City of Tukwila
**Planning and Community
 Development Committee**

SUBJECT: Community Development Update

STAFF REPORT TO THE PLANNING COMMISSION

- FILE NUMBER:** L19-0115 Comprehensive Plan/Zoning Code Amendment
- ASSOCIATED FILES:** E19-0011 SEPA Checklist
- REQUEST:** Zoning Code amendments to TMC 18.41 and new design guidelines for multifamily development in the Tukwila South Overlay (TSO) district.
- Planning Commission (PC) will hold a future public hearing on the proposed amendments and make recommendations to the City Council for review and adoption.
- PUBLIC HEARING:** The June 10, 2021, meeting is a continuation of the public hearing that commenced on March 18, 2021.
- LOCATION:** Lands within the Tukwila South Overlay district.
- STAFF:** Max Baker, Senior Planner
- ATTACHMENTS:**
- A. 4.22.2021 PC Meeting Staff Report – Applicant Comments Provided 4.22.2021 + Staff Responses
 - B. Draft Design Guidelines – Provided at 4.22.2021 PC Meeting

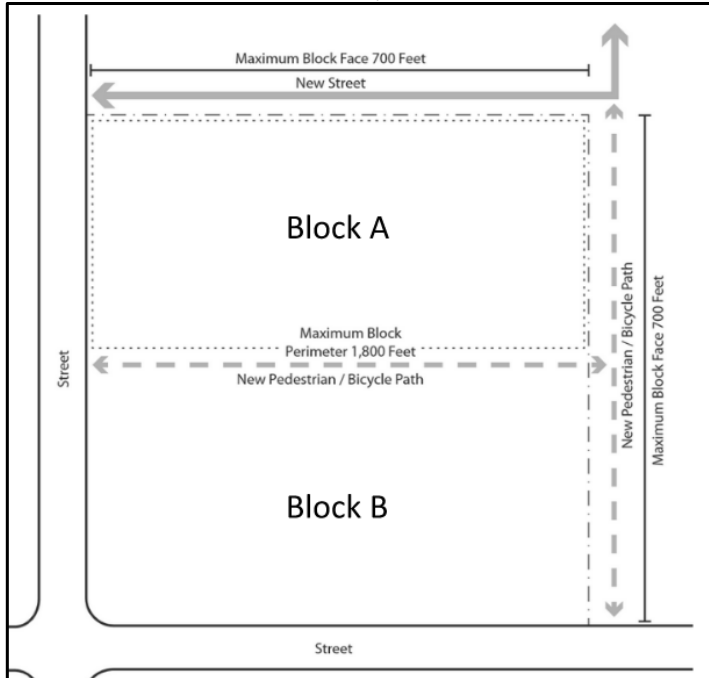
Commented [MP17]: Segale suggest this redlined language may be easier to measure as the perimeter is easy to find as opposed to 50% of the proposed units.

Commented [MB18R17]: Staff recommends using suggested language for proximity to recreation areas: “The closest structure containing residential units (not including accessory buildings such as fitness centers, parking garages, utility structures, etc. must be located within ¼ mile...”
